# **MAMARONECK SELF-STORAGE BUILDING ADDITION**

## **Final Environmental Impact Statement**

**Mamaroneck Self-Storage Building Addition  
Waverly Avenue/Fenimore Road  
Village of Mamaroneck  
Westchester County, New York  
(Tax Map #8-111-29-42)**

Figure  
III.A-1

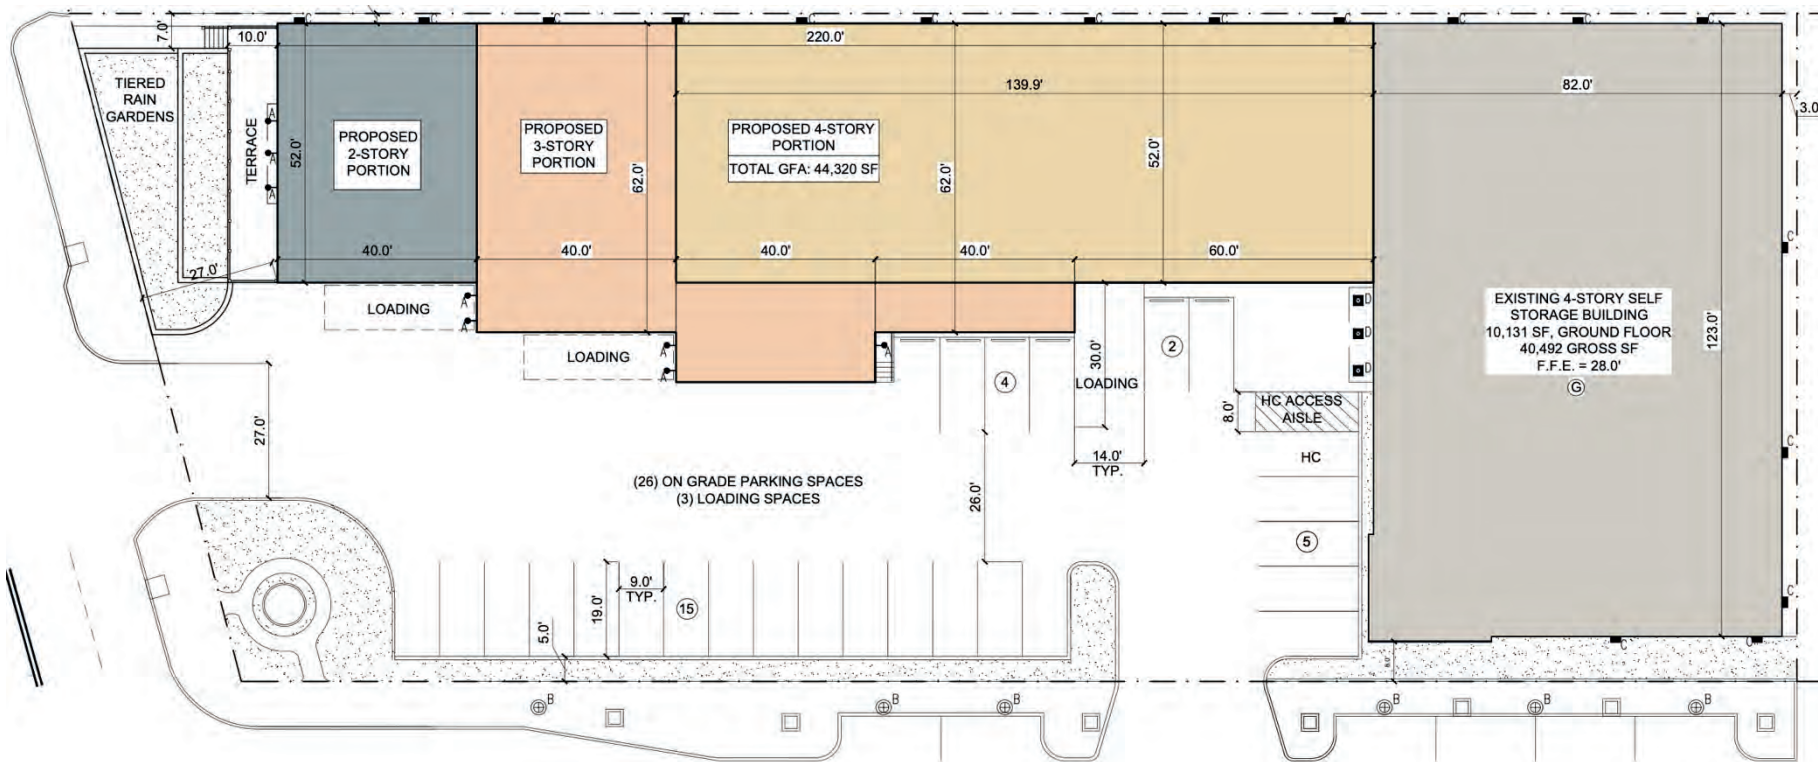
**A-2 Comment:**

The MAKER zone is a planning concept formulated in approximately 2017 for the approximately 70-acre area that is currently primarily zoned M-1 – Manufacturing (Figure III. A-1). As of this date, the MAKER zone has not been adopted, and is therefore, not applicable to the Proposed Action.

As depicted on Figure III.A-1, the MAKER zone is comprised of two overlay areas, a Retail Overlay and a Mixed-Use Overlay, within which the Site is located. Buffer and park areas are envisioned along the perimeter of the area. The following uses are encouraged in these areas:
